FINAL DRAINAGE REPORT FOR GLENEAGLE GOLF COURSE RESIDENTIAL INFILL DEVELOPMENT FILING NO. 2

February 12, 2019
Project Number 03524

VR-18-018

Markup Summary

DEVELOPED CONDITIONS

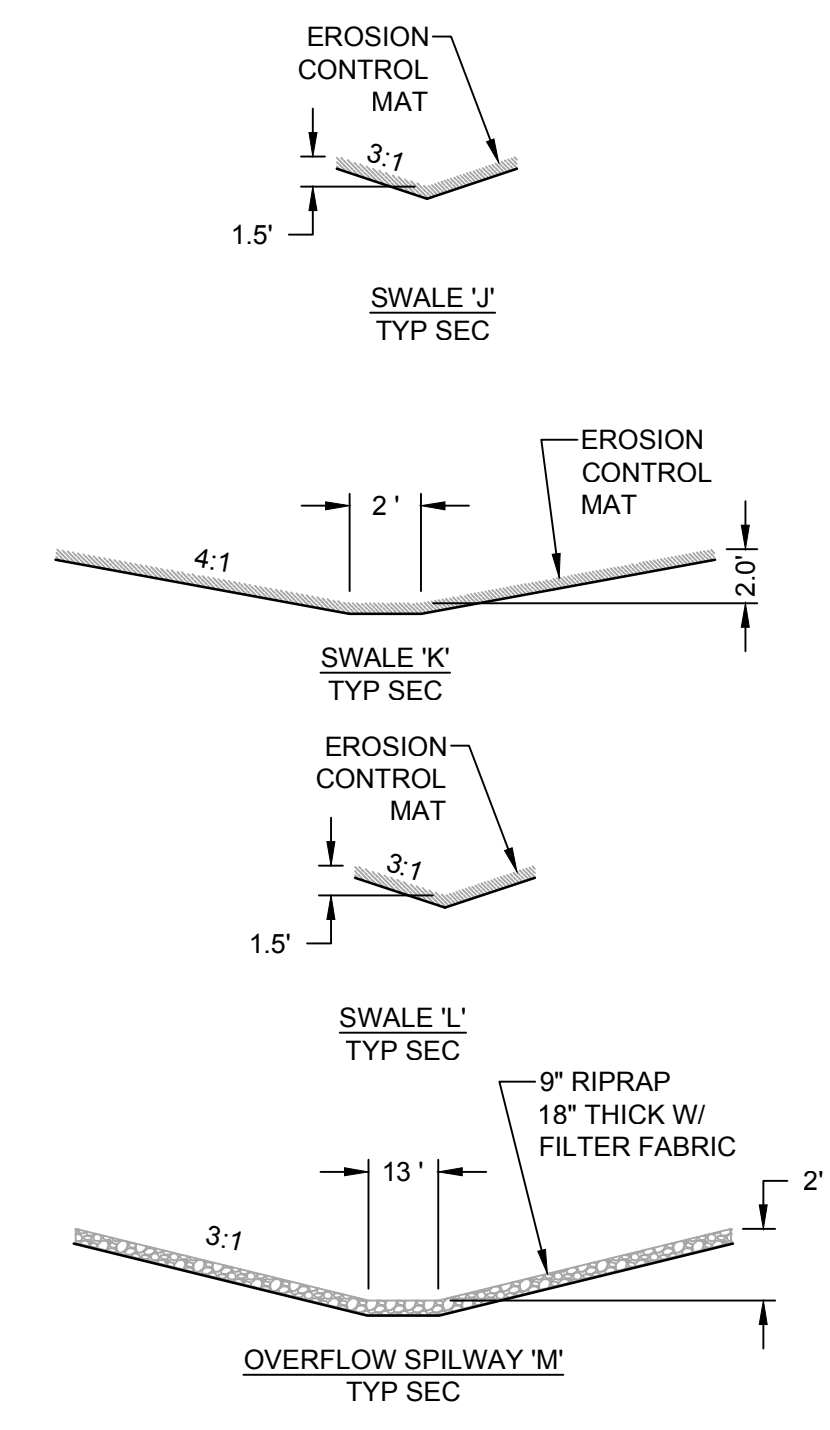
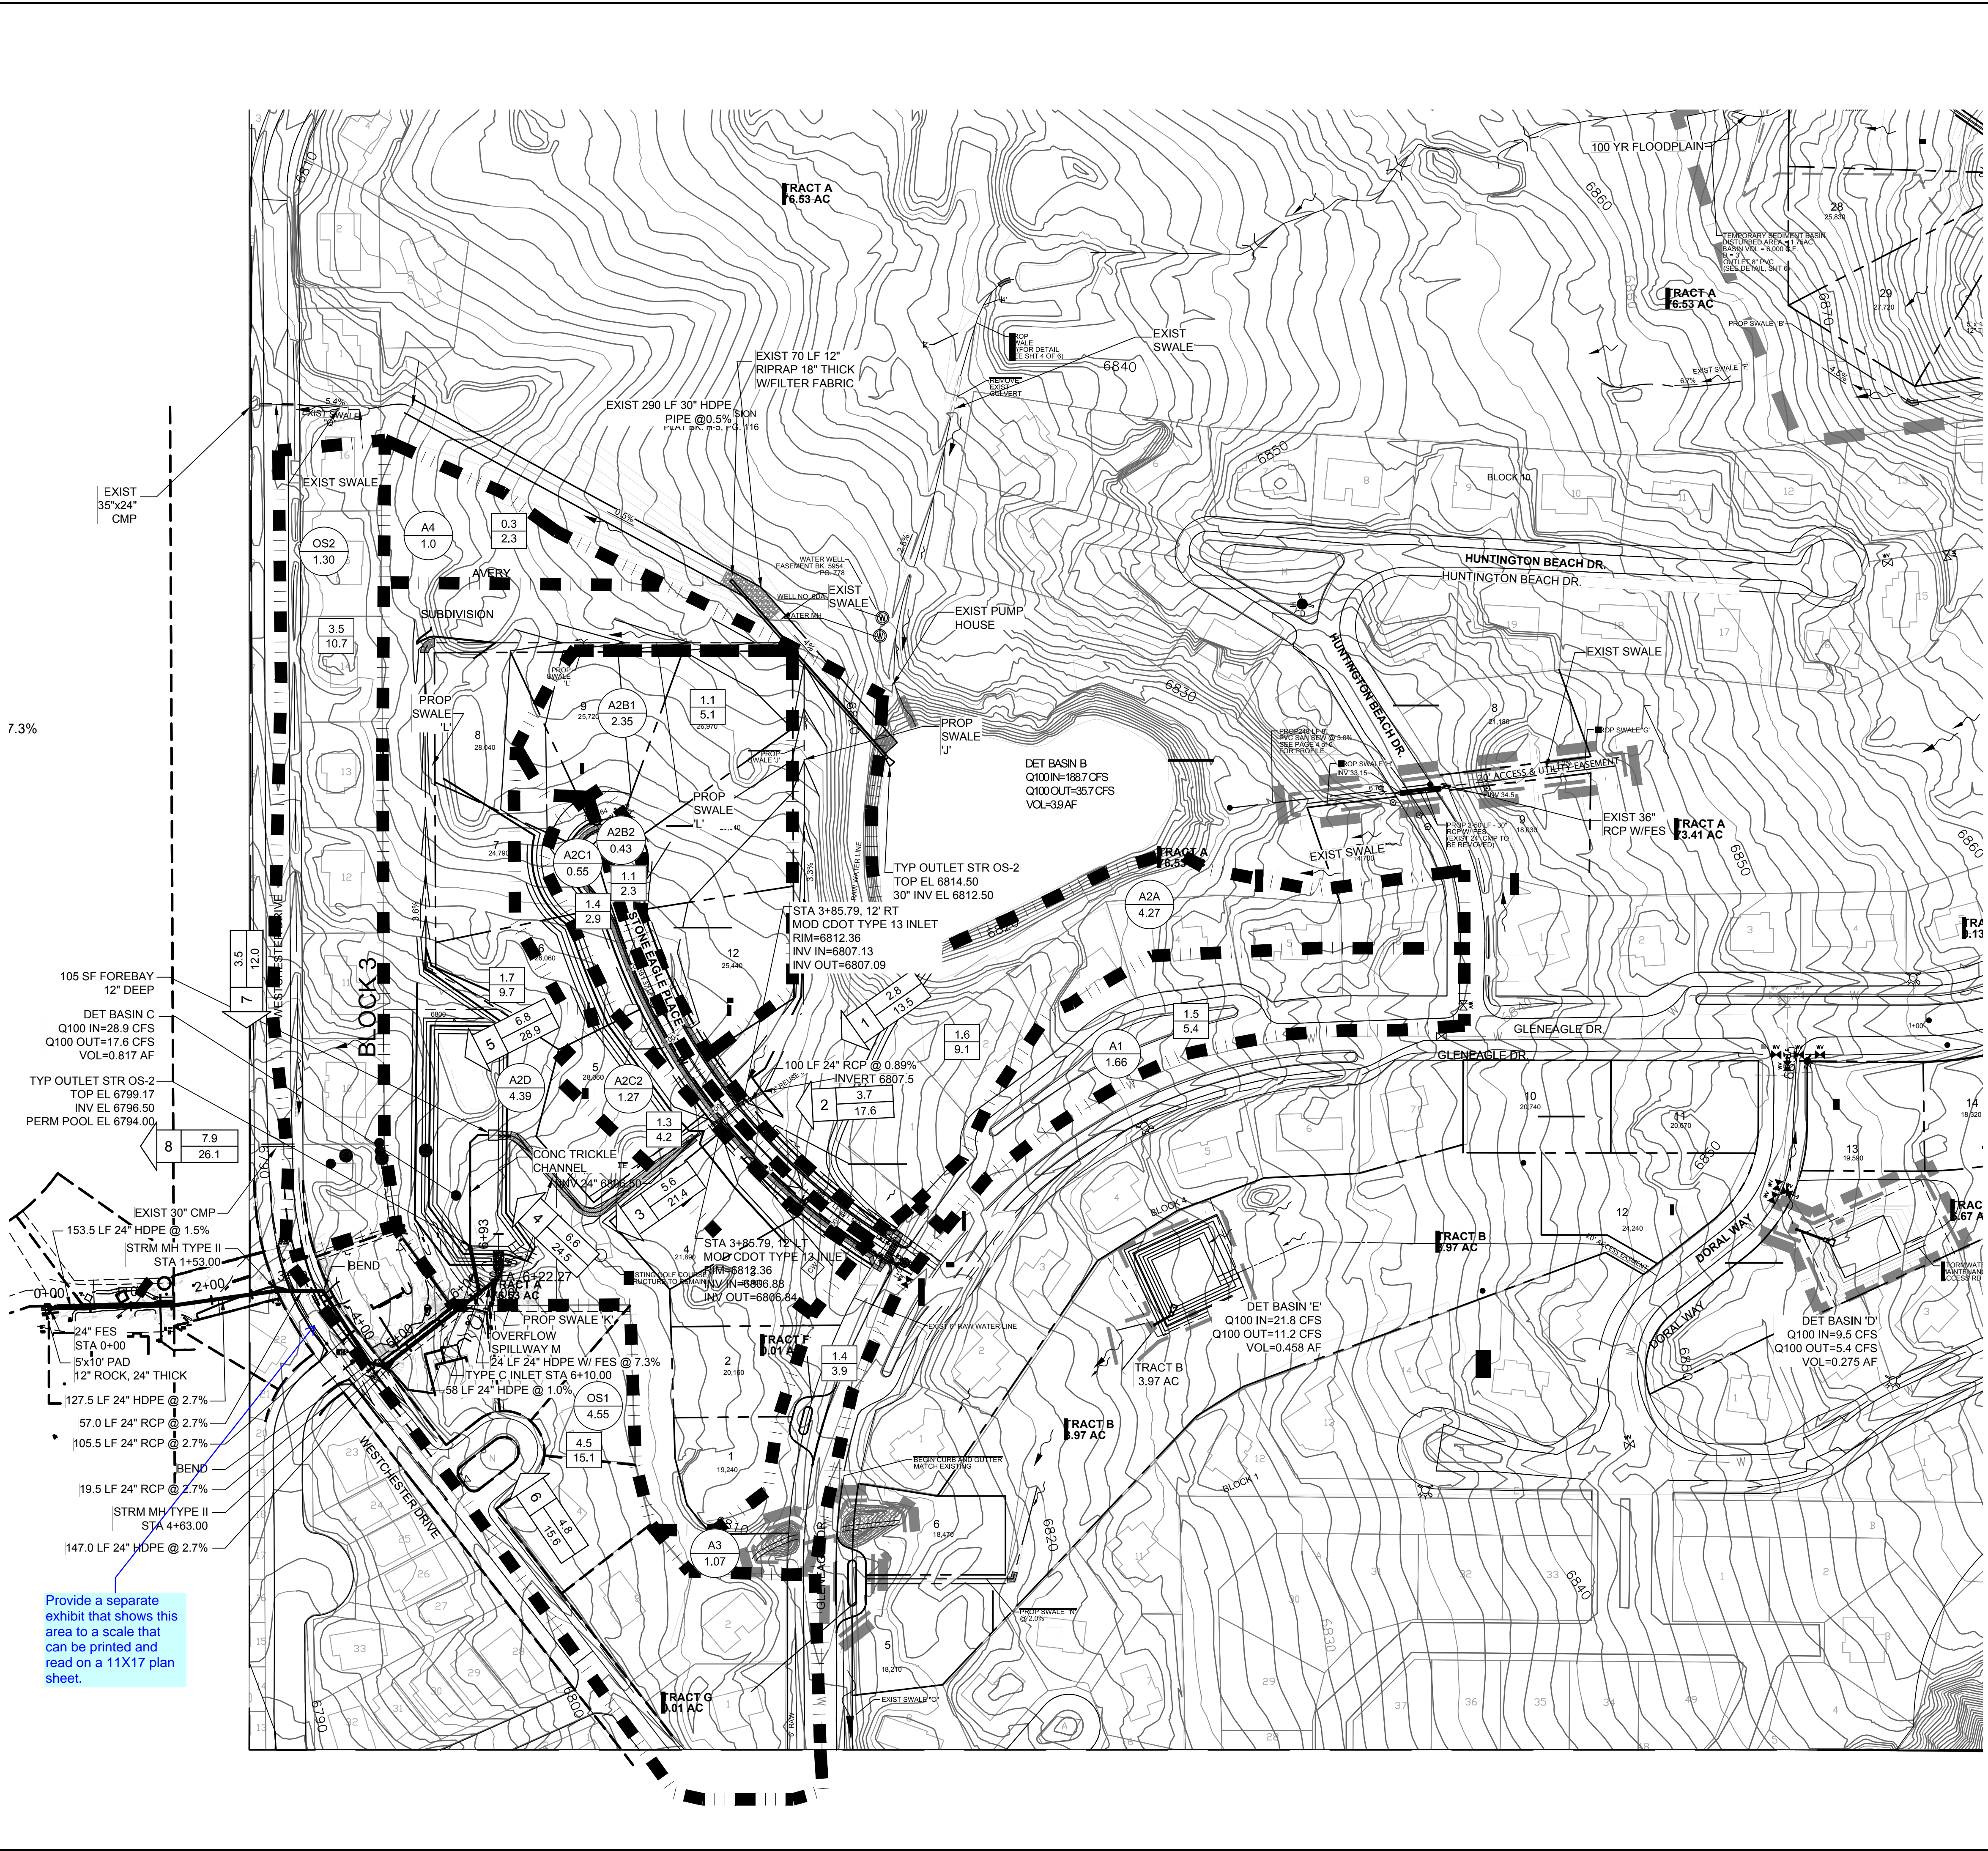
Provide a separate exhibit that shows this area to a scale that can be printed and read on a 11X17 plan sheet.

Provide a separate exhibit that shows this area to a scale that can be printed and read on a 11X17 plan sheet.
